II. Corrections and Additions to the Draft EIR

This section of the Final EIR provides changes to the Draft EIR that have been made to revise, clarify, correct, or add to the environmental impact analysis for LACMA Building for the Permanent Collection (the Project). Such changes are a result of public and agency comments received in response to the Draft EIR and/or new information that has become available since publication of the Draft EIR. The changes described in this section do not result in the Project creating any new or substantially increased significant environmental impacts.

The Applicant has proposed several modifications to the Project as described in the Draft EIR, which are primarily related to the design of the Museum Building. Refinements to the Museum Building include: (1) an overall square footage reduction from approximately 387,500 gross square feet to approximately 347,500 gross square feet; (2) a shift of the portion of the Museum Building crossing Wilshire Boulevard approximately 30 feet to the east; (3) a change in the geometry of the Pavilions to the Museum Building from polygonal to rectilinear forms and an alteration to the curvilinear geometry on the e

Figure II-1
Conceptual Site Plan of the Modified Project

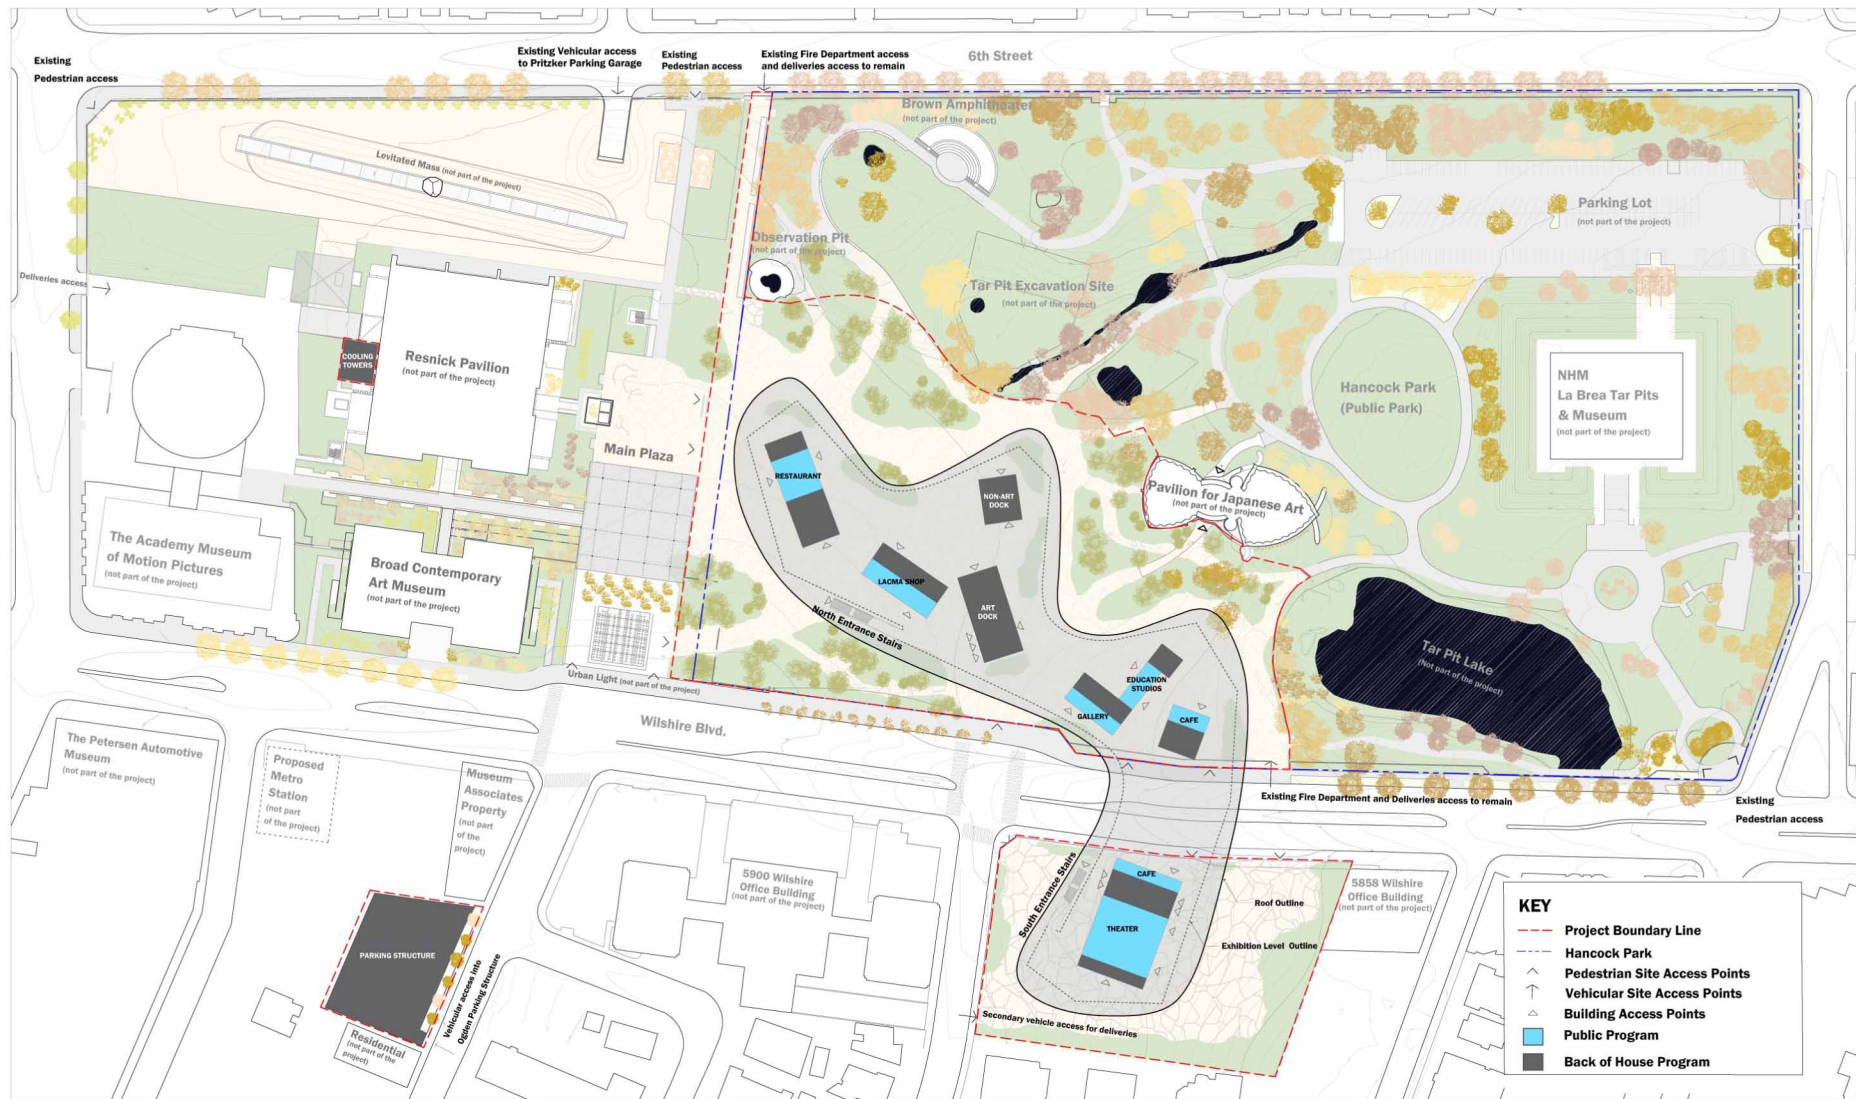
Figure II-1 on page II-4 and Revised Figure II-5 on page II-9 illustrate an alteration to the curvilinear geometry on the exhibition level. The Original Project Museum Building had a shape which resembled an “S.” Under the Original Project design, the portion of the Museum Building on LACMA East abutted the northwestern and the southwestern boundaries of LACMA East. However, the design of the Modified Project Museum Building has a shape which resembles a “W.” Under this Modified Project design, the Museum Building would be pulled back from the northwestern and southwestern Project boundaries of LACMA East. As the Museum Building would be pulled back from the southwestern boundary of LACMA East, the area between the Project boundary and the Museum Building would create a larger open space area that would encourage pedestrian activity between the Wilshire Boulevard right-of-way and north entrance stairs into the Museum Building. In addition, the Modified Project includes a change in the geometry of the Pavilions to the Museum Building from polygonal to rectilinear forms.

As illustrated further in Figure II-1 on page II-4 and Revised Figure II-5 on page II-9, the location and design of the Pavilions has changed under the Modified Project. Beginning on the Spaulding Lot, the Pavilion which would house the theater includes the same uses and would be in a similar location as what was proposed under the Original Project design; however, the Pavilion would incorporate more glazing for the theater, which would provide a more transparent view of the interior spaces of the Pavilion for pedestrians walking along Spaulding Avenue and Wilshire Boulevard. While the south entrance stairs would remain in the same location, the Modified Project would include a third pedestrian access point on the Spaulding Lot that would be accessed from underneath the portion of the Museum Building crossing Wilshire Boulevard.

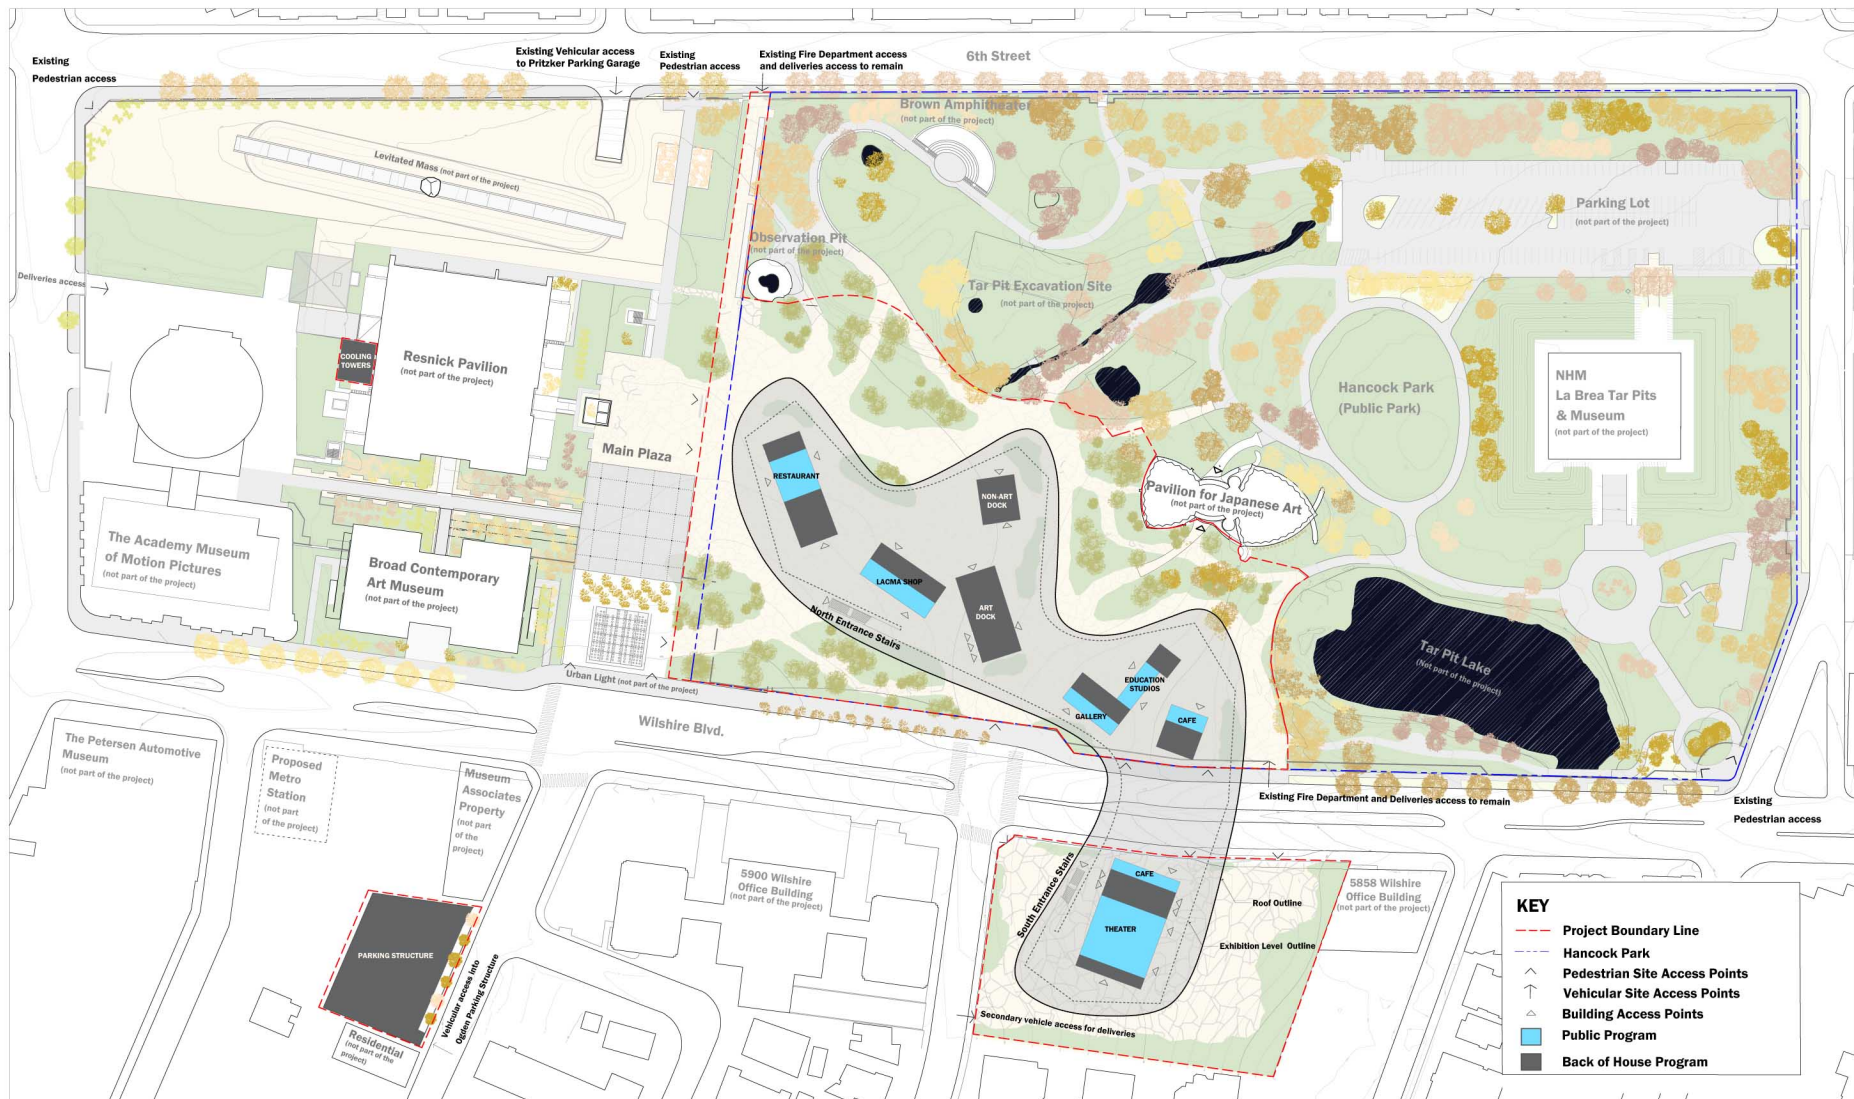
Volume 1, Section II, Project Description page II-18, replace Figure II-5 with Revised Figure II-5 on page II-9.
